December 29, 2021

**Subject: Pensacola Hydroelectric Project (FERC Project No. 1494-438);
Response to Comments on Initial Study Report, Notice of Technical
Meeting, and Request for Privileged Treatment of Cultural Resources
Information**

Figure 55
Overprediction and Underprediction of Simulated WSE at USGS Gages

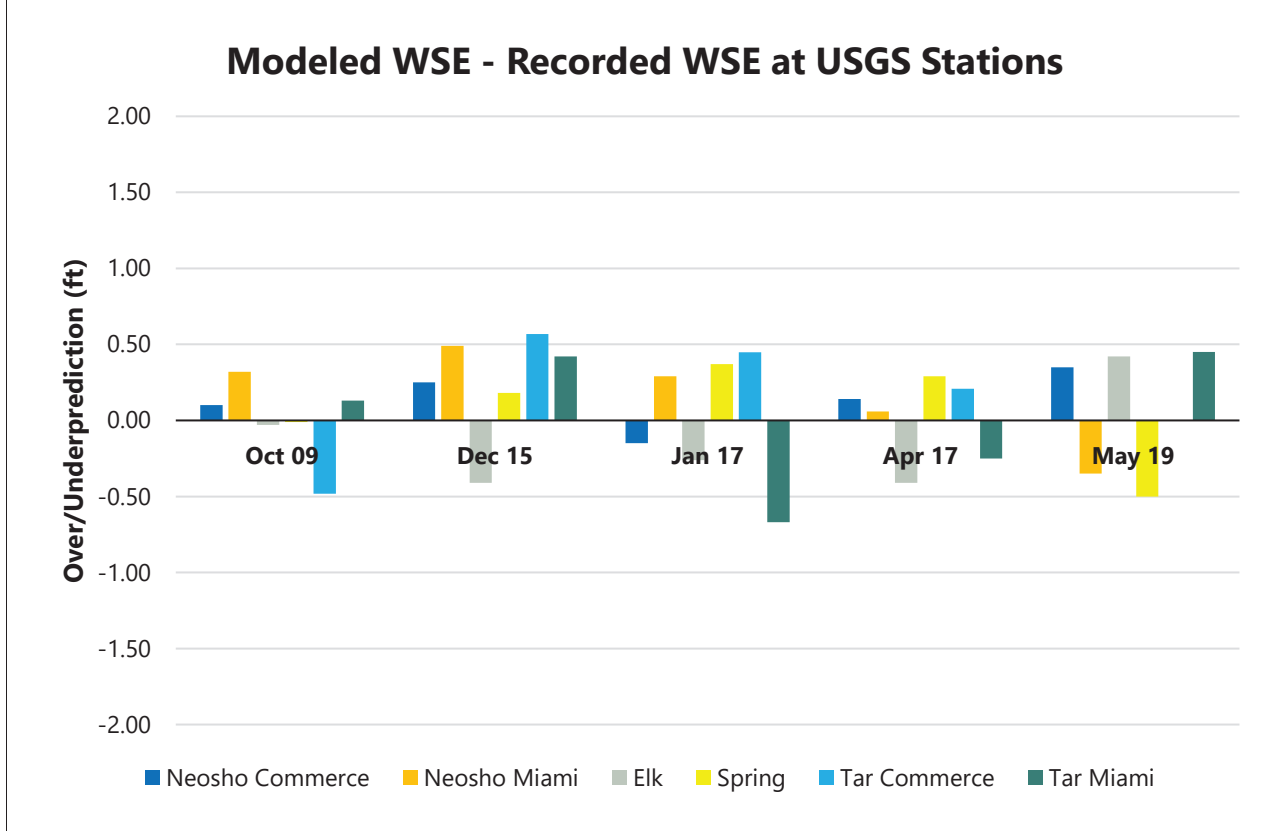
3	FERC Staff, 11/24/2021	Figure 13 of the UHM Report shows the over/under prediction of simulated water surface elevations at the four USGS gages. According to the USGS Neosho River gage at the city of Commerce, Oklahoma, the maximum water surface elevation of the July 2007 historical inflow event was 776.62 feet. However, there is no blue bar comparing the simulated and observed values, as there is for the other gages. Therefore, please revise Figure 13 to include the data point for the July 2007 event, or clarify why it was not included.	<p>At the time of model calibration (March 2021), GRDA did not possess USGS data for the July 2007 event for the Neosho River gage at the City of Commerce, Oklahoma. On USGS's website, stage data were only available in hourly increments from October 2007 onward.</p> <p>Following the Model Input Status Report (filed with FERC on March 30, 2021), the City of Miami filed comments on the Model Input Status Report with FERC (filed on June 23, 2021). The City of Miami stated that hourly gage data that pre-dated October 2007 for the Neosho River gage at Commerce was available upon request from USGS. GRDA contacted USGS and requested data for the July 2007 event.</p> <p>USGS delivered the July 2007 stage data to GRDA with a disclaimer that the possibility exists that the data provided "was not processed in accordance with current USGS standards and could contain errors." Because of this disclaimer, GRDA searched for other USGS data. Two additional data sources exist:</p> <ol style="list-style-type: none"> 1. Peak streamflow, which is the maximum flow that occurred during the USGS water year. Stage associated with the peak streamflow is reported by USGS.

3. Figure 13 of the UHM Report shows the over/under prediction of simulated water surface elevations at the four USGS gages.⁴ According to the USGS Neosho River gage at the city of Commerce, Oklahoma, the maximum water surface elevation of the

July 2007 historical inflow event⁵ was 776.62 feet. However, there is no blue bar comparing the simulated and observed values, as there is for the other gages. Therefore, please revise Figure 13 to include the data point for the July 2007 event, or clarify why it was not included.

#	Entity	Comment	GRDA Response
			<p>2. Streamflow measurements, which are USGS field measurements and are independent of gage-recorded values. USGS reports flow and gage height for streamflow measurements.</p> <p>GRDA compared the USGS data to the HEC-RAS model results at the Commerce gage. The magnitude of the differences between HEC-RAS results was similar to the magnitude between the various USGS measurements.</p> <p>When considering whether to update Figure 13 in the UHM Report with data received from USGS, GRDA considered the following:</p> <ol style="list-style-type: none"> 1. USGS included a disclaimer on the data, noting that the data may not have been processed in accordance with current USGS standards and could contain errors. 2. Differences between various USGS measurements were similar to the differences between HEC-RAS results and USGS measurements. 3. USACE cautions HEC-RAS users that a $\pm 5\%$ flow measurement, which may be “optimistic,” can translate to a stage error of ± 1 foot. Considering the differences between various USGS measurements, there may be errors for the July 2007 event flow measurement that result in stage errors of 1.0 feet or more. 4. The City of Miami expressed a lack of comfort regarding the July 2007 USGS data in their comments on the <i>H&H Modeling: Upstream Hydraulic Model – Model Input Status Report</i>. The City of Miami’s comments were filed with FERC on June 23, 2021. <p>Based on these considerations, GRDA determined that updating Figure 13 to include a blue bar representing over/under prediction of simulated water surface elevations at the Commerce gage could mislead the reader to assume a disagreement between simulated and measured data where there is no such disagreement.</p>
